Re: Comment Letter – Order No. R4-218-XXXX

NPDES No. CA0064203

Waste Discharge Requirements for Los Angeles Turf Club, Inc.

Santa Anita Park

Los Angeles Turf Club NPDES Implementation Schedule July 20, 2018

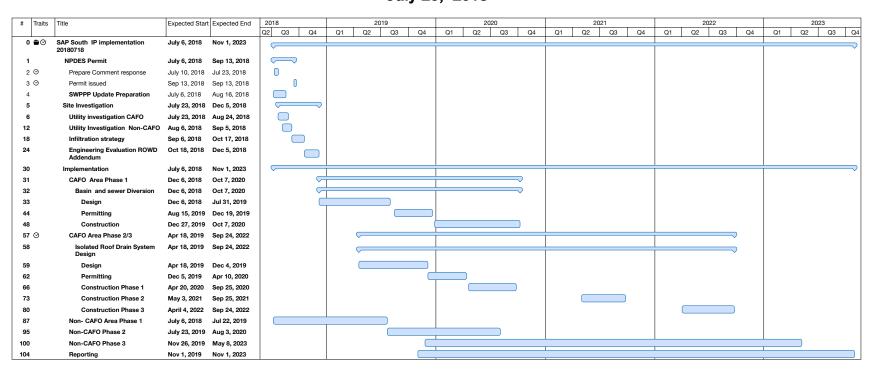
As part of the discussions and requests by Water Board staff regarding the CAFO Basin, SAP prepared a more detailed schedule (<u>Attachment 1</u>) that details the site investigation, engineering and permitting work efforts required to complete construction of the sewer diversion, CAFO Basin and roof diversion. The CAFO basin construction will be expedited wherever feasible and will depend upon construction constraints and other factors outside of SAP's control, including but not limited to required local jurisdiction and other approvals necessary for construction. The Water Board staff is also aware of the limitations and constraints of construction of a roof drain storm diversion system in the fully occupied stable area due to horse and human safety.
